Docket Number:	12-AFC-02
Project Title:	Huntington Beach Energy Project
TN #:	201173
Document Title:	City of Huntington Beach, Department of Planning and Building Comments on PSA Part A
Description:	PSA Part A comments
Filer:	Aaron Klemm
Organization:	City of Huntington Beach
Submitter Role:	Public Agency
Submission Date:	11/13/2013 10:48:04 AM
Docketed Date:	11/13/2013

**SUBJECT: CITY OF HUNTINGTON BEACH COMMENTS REGARDING
HUNTINGTON BEACH ENERGY PROJECT
PRELIMINARY STAFF ASSESSMENT – PART A
DOCKET NO. 12-AFC-02**

PROJECT NAME: AES HUNTINGTON BEACH ENERGY PROJECT (HBEP)

FIGURE 2.1-1
General Arrangement/Site Plan
 AES Huntington Beach Energy Project
 Huntington Beach, California

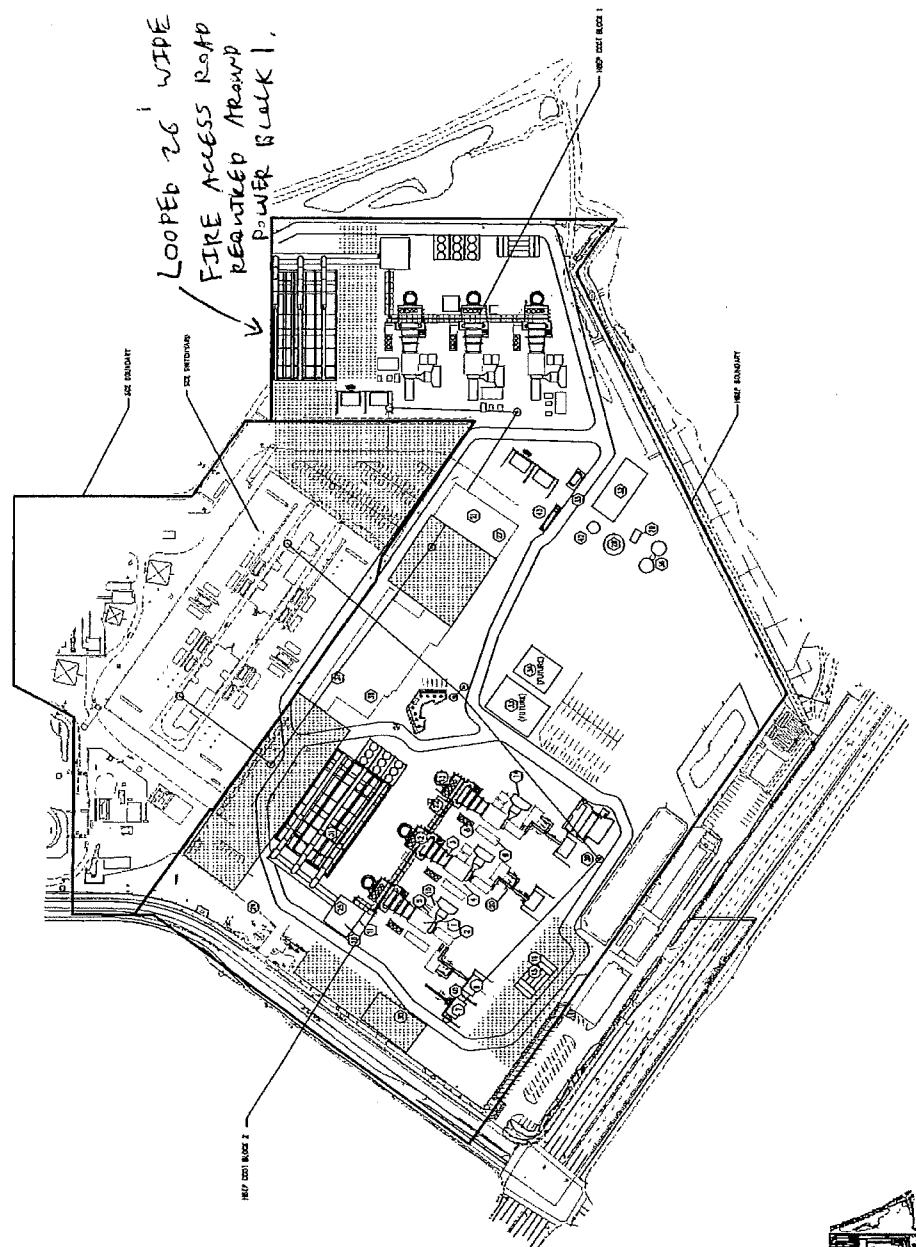
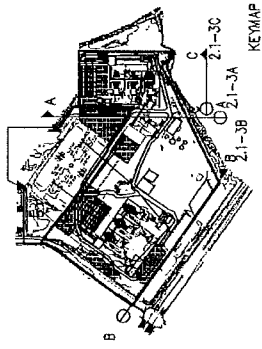
1. Page 4.14-13, Compliance with LORS: Currently, the Fire Department Access to the project does not comply with LORS. Figure 2-1.1 shows the proposed Fire Access Road which currently does not comply with the access road requirements identified below. To comply with the turnaround requirements in City Specification #401, a looped 26 foot wide Fire Department Access Road is required around Power Block 1 (please see HBFD marked up Figure 2-1.1 attached). All portions of the fire access road are required to meet the turning radius, width, and signage requirements indicated in the attached Fire Department Code Requirements. The Fire Access Road is required to extend within 150 feet of all portions of the first floor of any proposed structures as per Section 503 of the California Fire Code and Section 503 of the Huntington Beach Fire Code.

Currently, the Fire Department Access to the project does not comply with the local laws, ordinances, regulations, and standards (LORS). Figure 2-1.1 shows the proposed Fire Access Road which currently does not comply with the access road requirements identified below. To comply with the turnaround requirements in City Specification #401, a looped 26' wide Fire Department Access Road is required around Power Block 1 (please see HBFD marked up Figure 2-1.1 attached). All portions of the fire access road are required to meet the turning radius, width, and signage requirements indicated below. The Fire Access Road is required to extend within 150' of all portions of the first floor of any proposed structures as per Section 503 of the California Fire Code and Section 503 of the Huntington Beach Fire Code.

Fire Access Roads shall be provided and maintained in compliance with City Specification # 401, *Minimum Standards for Fire Apparatus Access*. Driving area shall be capable of supporting a fire apparatus (75,000 lbs and 12,000 lb point load). Fire access roads fronting commercial

buildings shall be a minimum width of twenty-six feet (26') wide, with thirteen feet six inches (13' 6") vertical clearance. For Fire Department approval, reference and demonstrate compliance with City Specification # 401 *Minimum Standards for Fire Apparatus Access* on the plans. (FD)

Fire Access Road Turns and Corners shall be designed with a minimum inner radius of seventeen feet (17') and a minimum outer radius of forty five feet (45') per City Specification # 401 *Minimum Standards for Fire Apparatus Access*. For Fire Department approval, reference and demonstrate compliance with City Specification # 401 *Minimum Standards for Fire Apparatus Access* on the plans. (FD)
